DATE: March 13, 2026
TO: ALL CONTRACTORS
FROM: DUSTIN TILL
PROJECT: ROSCOE ROAD WATER TREATMENT PLANT
ORANGE BEACH WATER AUTHORITY
GMC PROJECT NO. CMOB230049
RE: ADDENDUM #5

ADDENDUM NUMBER 5

ROSCOE ROAD WATER TREATMENT PLANT

GMC PROJECT NO. CMOB230049

**CIVIL SITE PLAN
ENLARGED YARD
PIPING**
C-302

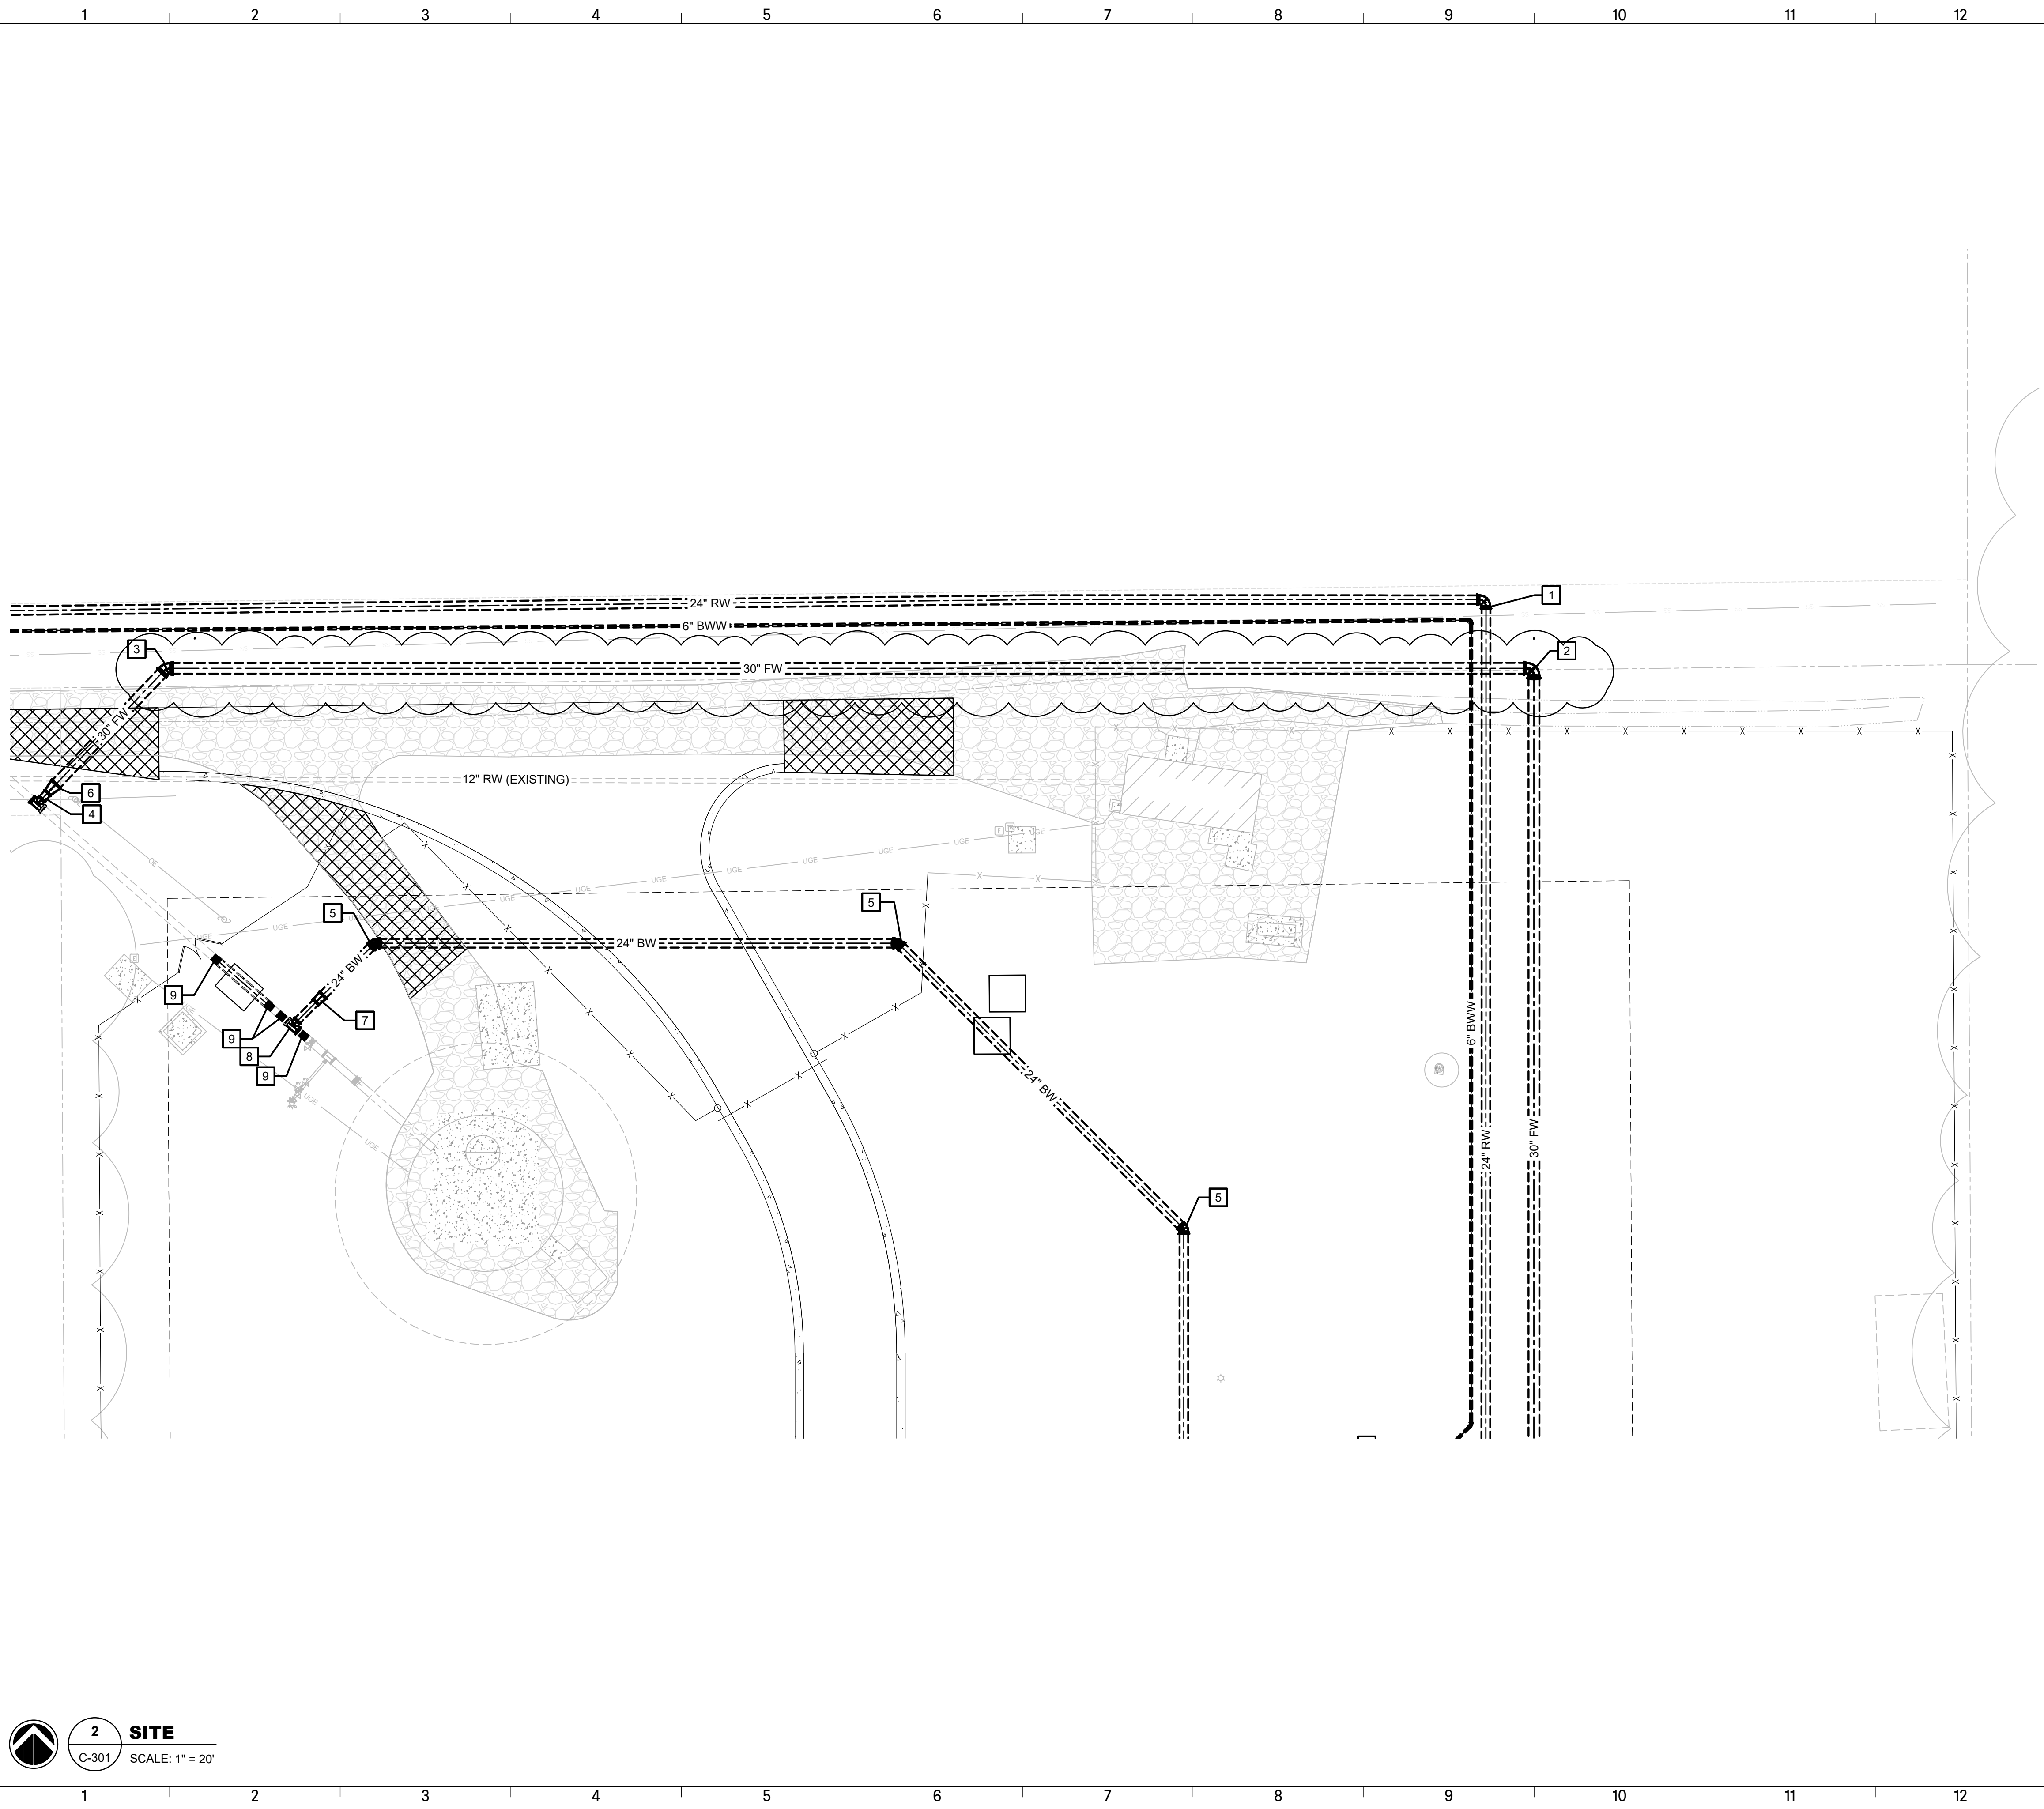
- 5.16 **Question: Are there any existing sewer piping that will require concrete encasement for the Potable water mains? Based on Specification 33 11 16, if a potable water main cannot maintain a minimum 10-foot horizontal separation from sewer piping, and also cannot be installed with its bottom a minimum of 18 inches above the top of the sewer, then the potable water main must be encased in concrete with a minimum depth of 6 inches.**

Answer: Potable water lines shall have a minimum of 5 ft horizontal separation from sewer lines. The 30" FW line has been shifted to the south to maintain the required clearance from the existing sewer line. See revised drawing C-302 that is included as an attachment to this addendum. No existing sewer piping will require concrete encasement.

D-604

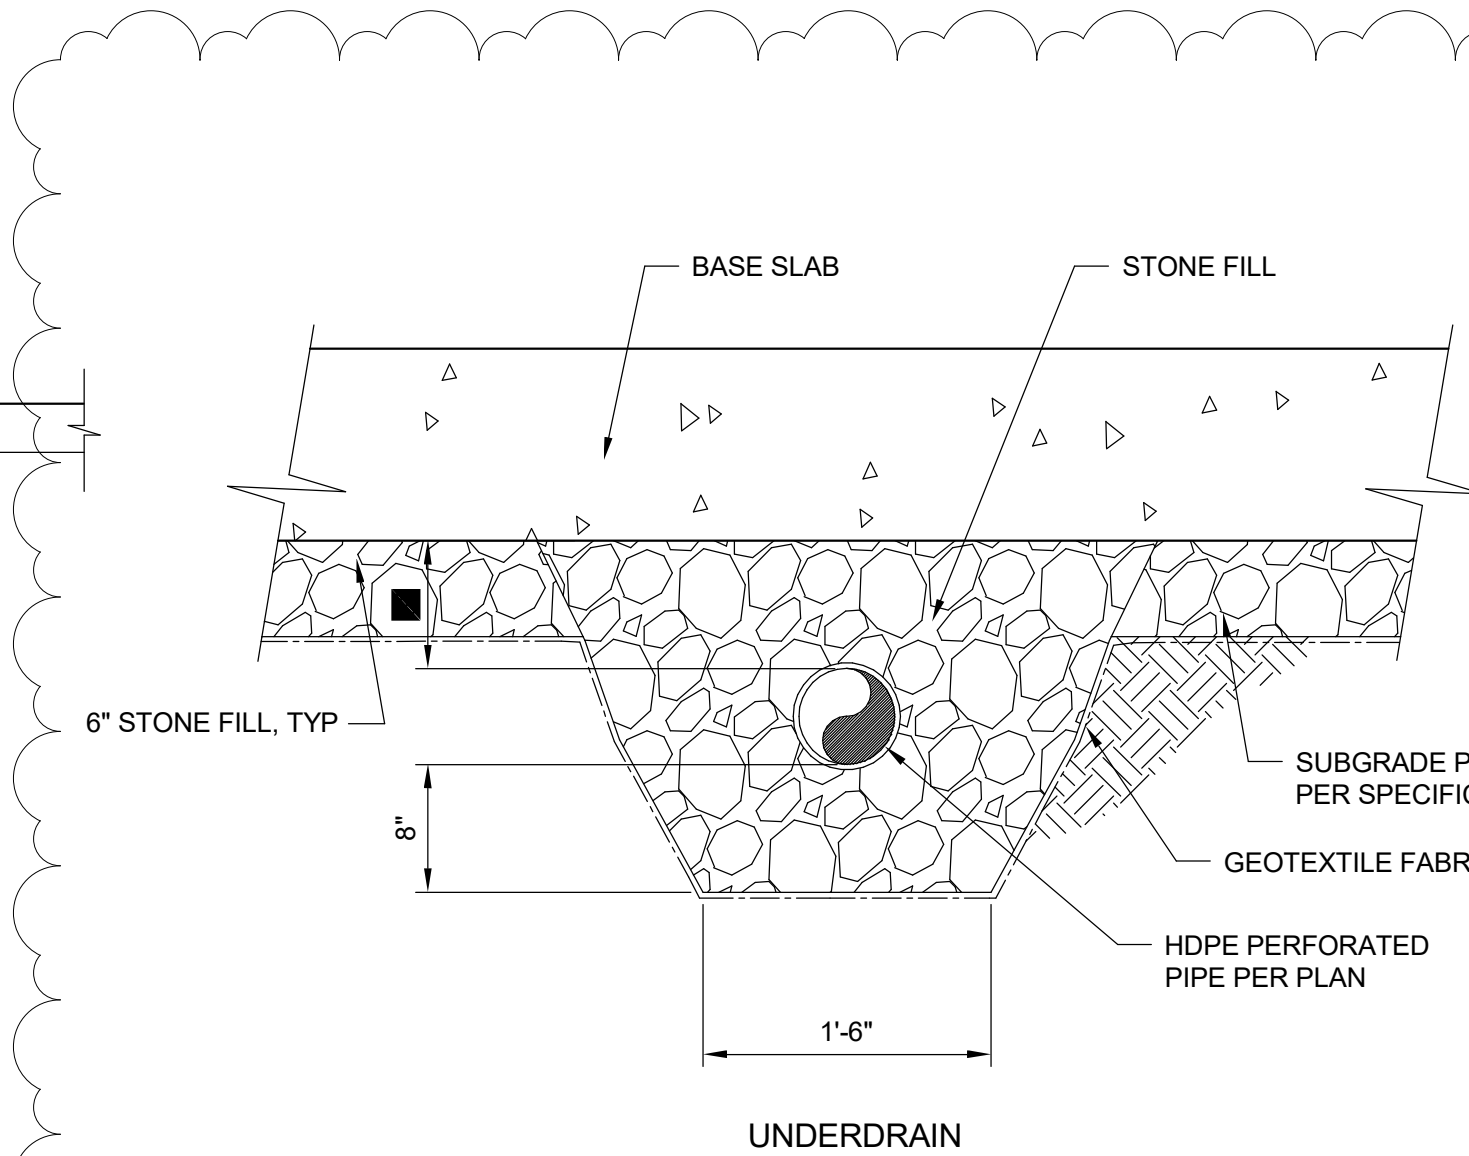
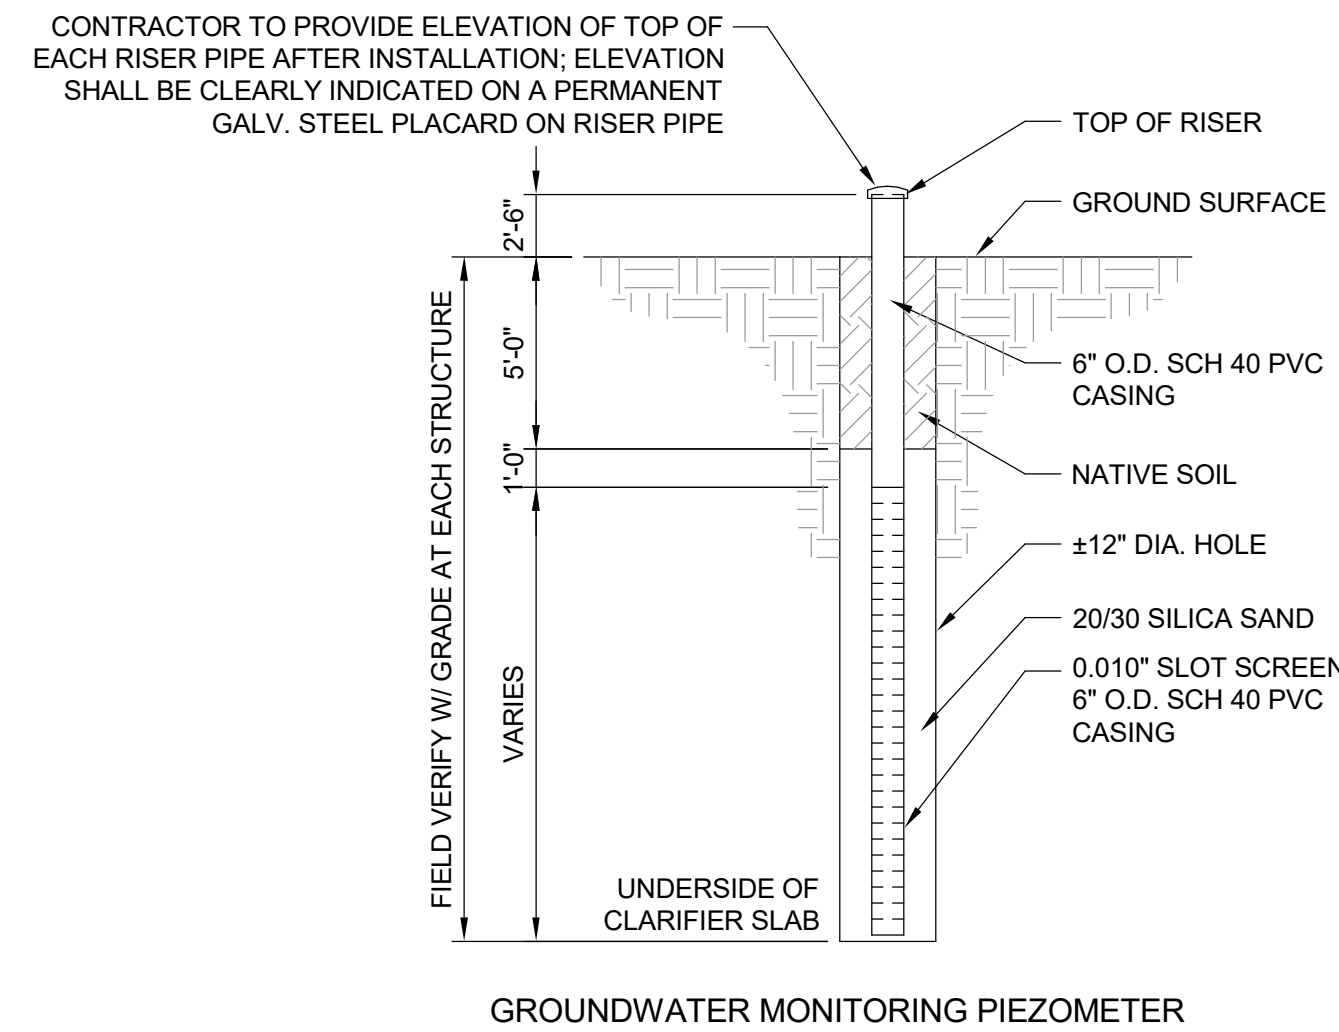
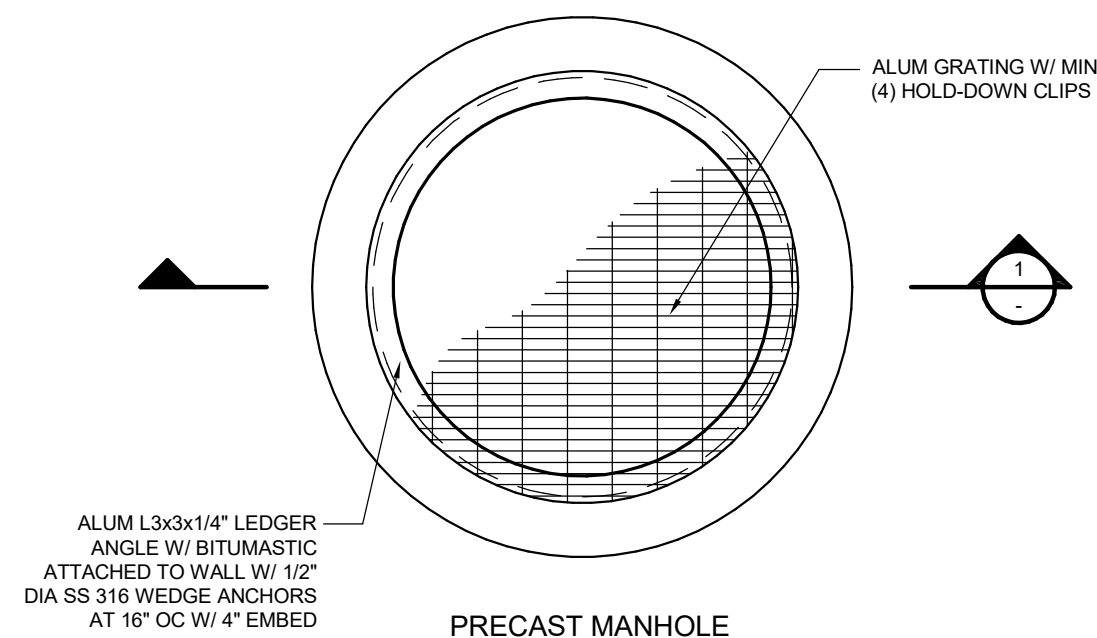
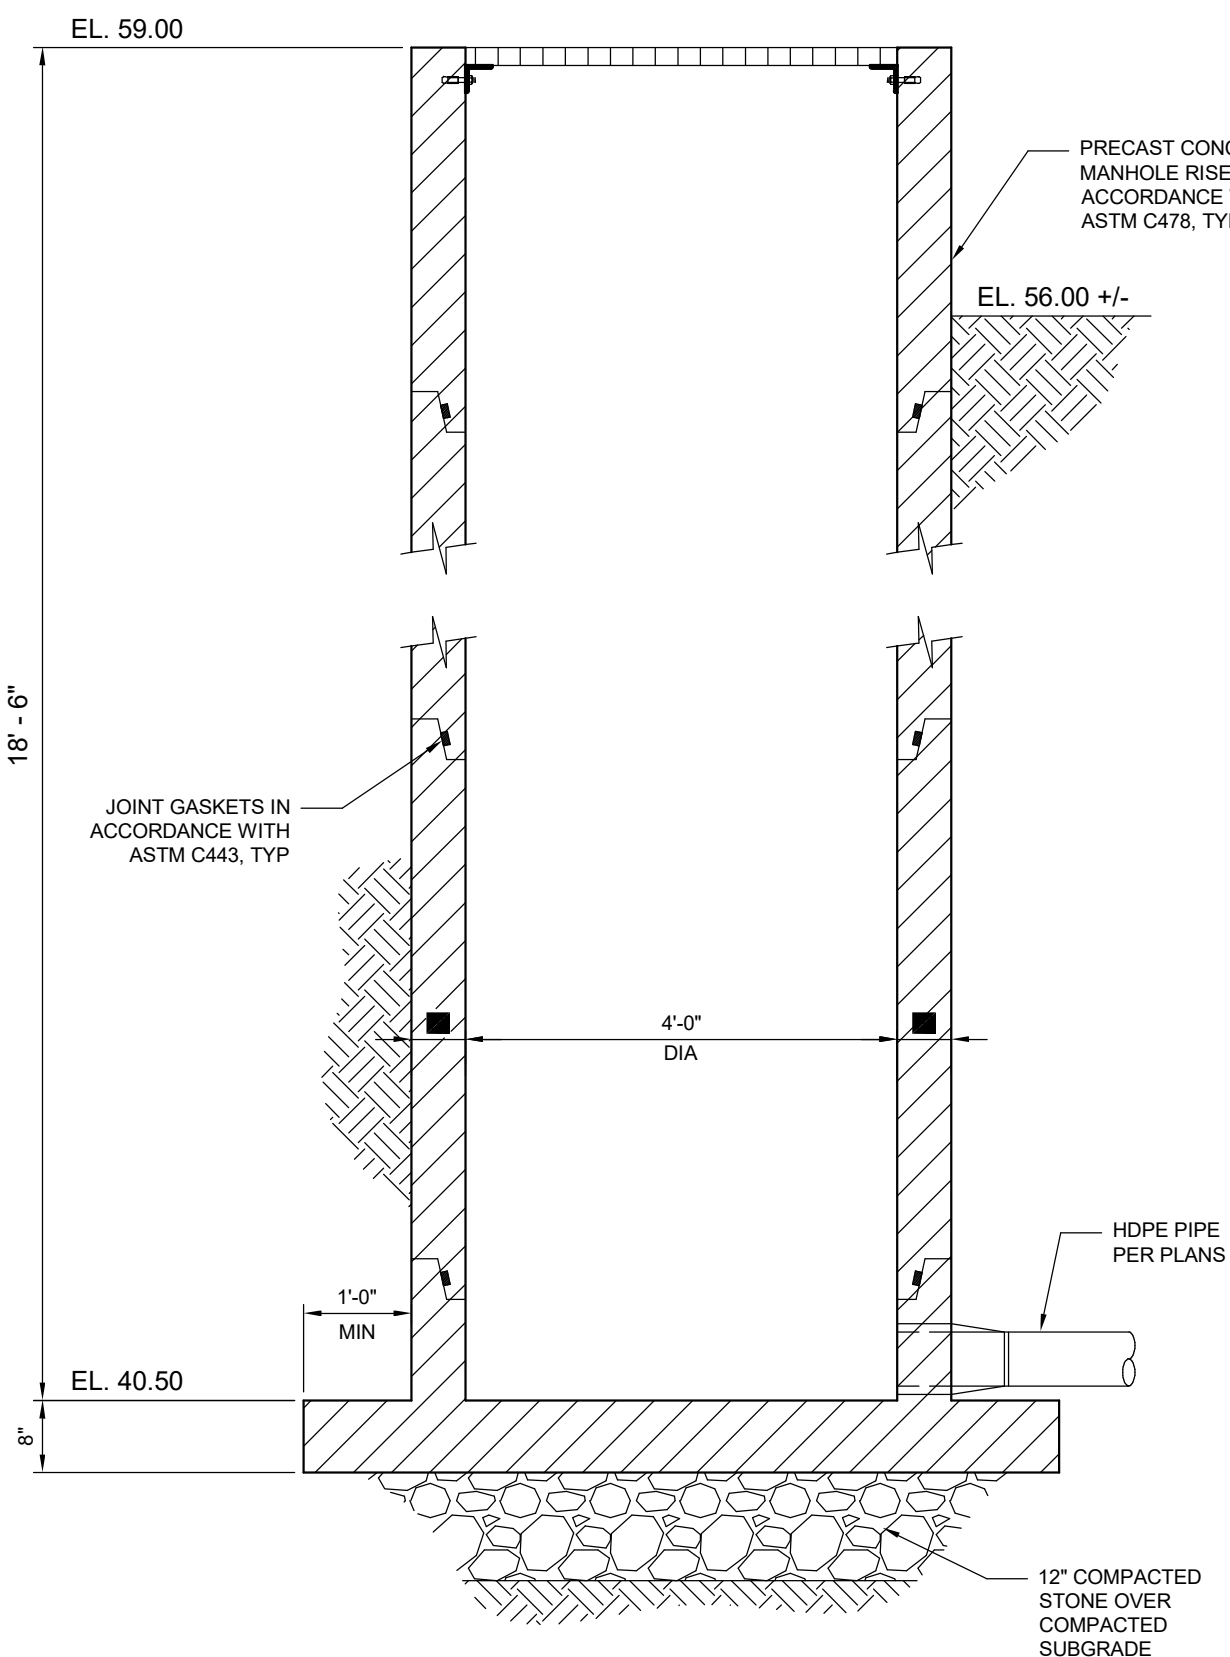
- In Part 3.5.A.3, change ‘T8210’ to ‘T8510’
- 2.7 An underdrain system has been added for each clearwell. See Sheets D-604 and D-605 that are included as an attachment to this addendum.
